INDIANA DEPARTMENT OF TRANSPORTATION

STANDARDS COMMITTEE MEETING MINUTES

RE: Minutes for the October 19, 2006 Standards Committee Meeting

REVISION TO STANDARD DRAWING
503-CCPJ-01, Type D-1 Contraction Joint

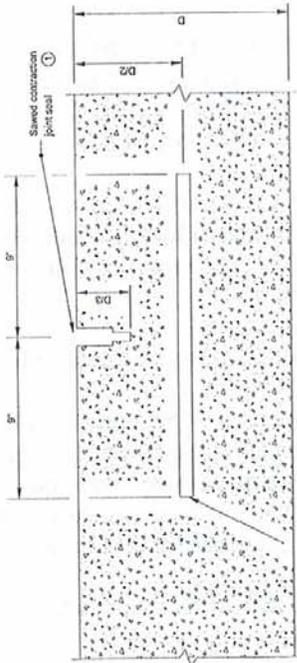
This revision proposes the deletion of the word "Minimum" from the table of dowel bar sizes.
